Subject: Transmittal of Revision 1 to Service Bulletin Number V2500-NAC-78-0038

V2500-NAC-78-0038 Transmittal Page 1 of 1 NACELLE - EXHAUST - THRUST REVERSER No. 4 HINGE WASHERS -REPLACEMENT OF

October 1, 1995 Revision 1 - February 20, 1997 V2500-NAC-78-0038
Page 1 of 10

No. 4 Hinge Modification -After Condition Figure 1

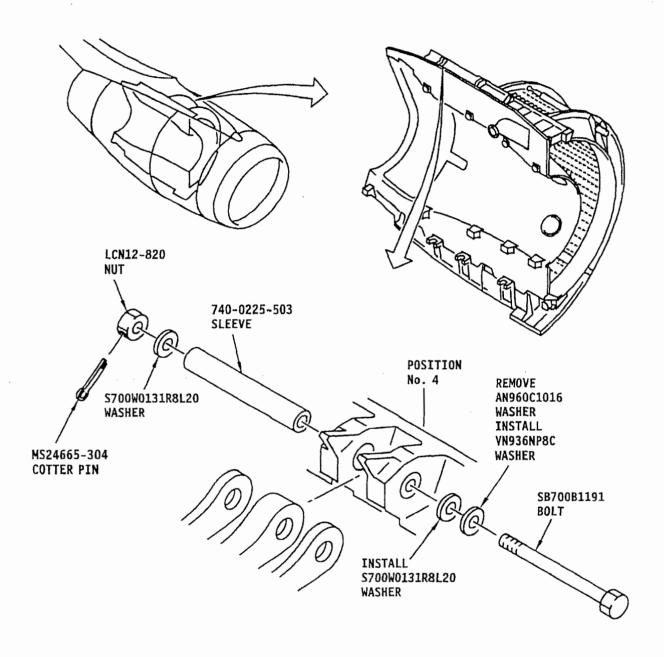
(1) To replace the illustration in Figure 1..

Replace the AN960C1016 washer under the bolt head with VN936NP8C washer and add anouther S700W0131R8L20 washer under the new VN936NP8C washer.

- B. Rework or Modification Instructions
  - (1) Remove bolt, washers, sleeve, and nut from No. 4 hinge. Discard AN960C1016 washer. (Refer to Figure 1).

- (2) Lubricate S700B1191 bolt with CoMat 10-058 penetrating oil.
  - (3) Install S700B1191 bolt, VN936NP8C washer, two S700W0131R8L20 washers, and LCN12-820 nut.

- (4) Torque nut to 480 -690 lb-in. (54.2 -78.0 N.m).
  - (5) Install MS24665-304 cotter pin in bolt.
- C. Post-requisite Instructions
  - (1) Install the hinge access panels as specified in A320 Aircraft Maintenance Manual, Chapter 78-32-00.
